BFX-UA300 Control Run New FFC Cable Result Report

Prepare by: PE Thuc

Date : 2022.07.16

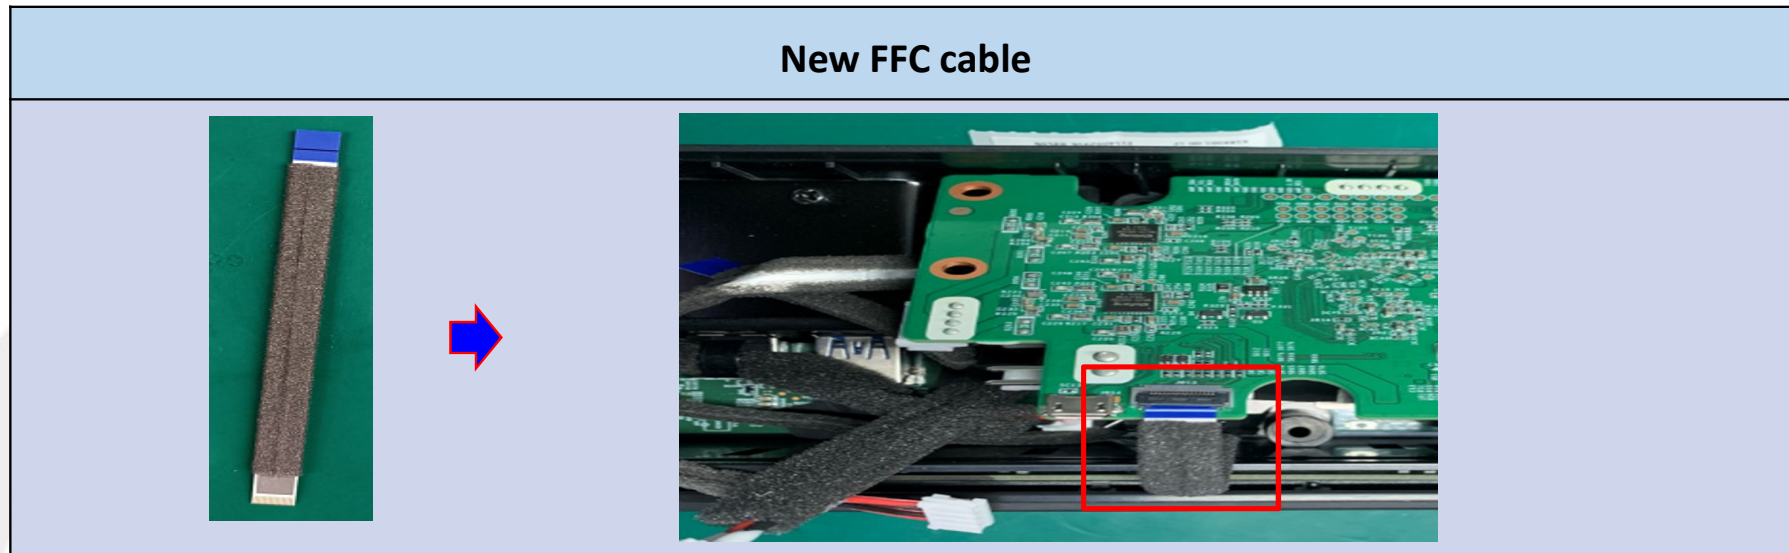
Date: 2022.07.07 PM request ALT agree to use new AMP FFC cable (with Kapton tape) for long-term solution to avoid AMP FFC cable pierced issue.

+ P/N : 376.00039.005

+ Vendor: P-TWO

TYPE	Overview			Dimension	Thickness
New FFC cable				No difference with old FFC cable	Mylar stick inside copper foil

No need stick Mylar for FFC AMP cable
